\_\_\_\_\_  
In the Matter of )  
 )  
LONG ISLAND LIGHTING COMPANY )  
 )  
(Shoreham Nuclear Power Station, )  
 )  
Unit 1) )  
\_\_\_\_\_

Docket No. 50-322-OL-3  
(Emergency Planning)

DIRECT TESTIMONY OF DAVID T. HARTGEN, Ph.D., P.E., ON BEHALF OF  
THE STATE OF NEW YORK REGARDING IMMATERIALITY ISSUES

REV 5 DESIRE LINES (COMPUTER MODEL)  
50% NON-COMPLIANCE/UNCONTROLLED

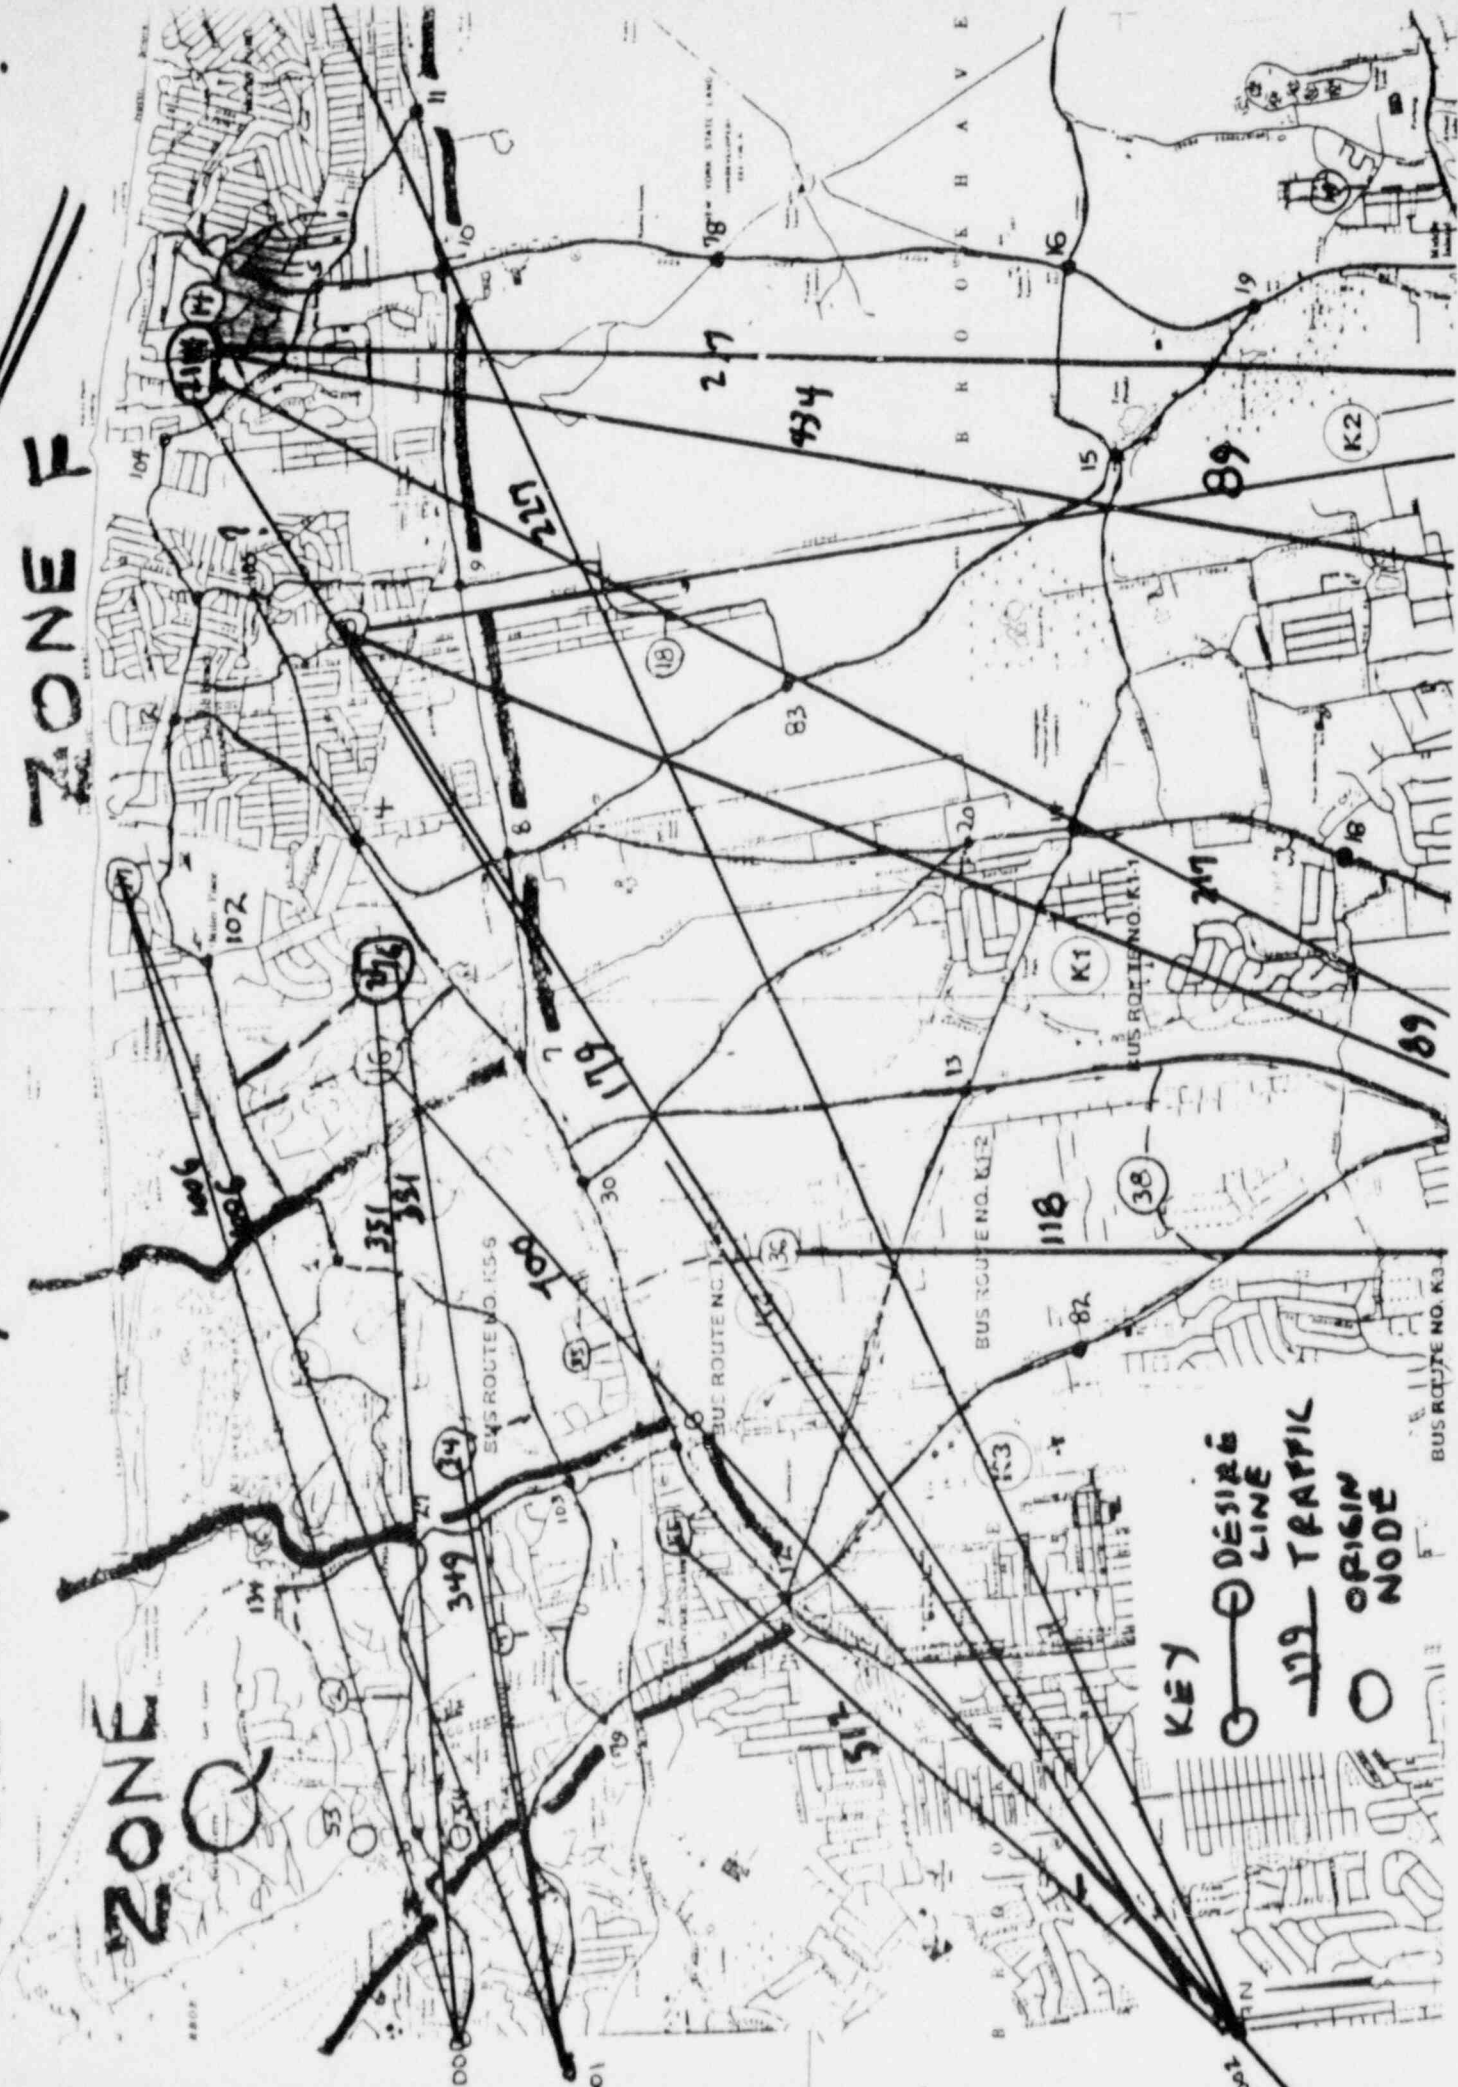
- o Spreading the traffic from loading node 14 and loading node 15 among 3 southern destinations, not to the west
- o Deleting the desire lines between loading nodes 2 & 7 and destinations 8001 and 8002 (Rt. 25A).

First, LILCO misrepresents the "uncontrolled" scenario. See Attachment 7 hereto. In fact, the evacuation is NOT uncontrolled, but is subtly controlled through the network structure and desire line pattern. By deleting and adding links and nodes, and using desire lines to conform with those deleted or added links and nodes, LILCO "controls" the evacuation in the supposedly uncontrolled tests. The "control" actually present in the so-called "uncontrolled" scenario is the insertion and
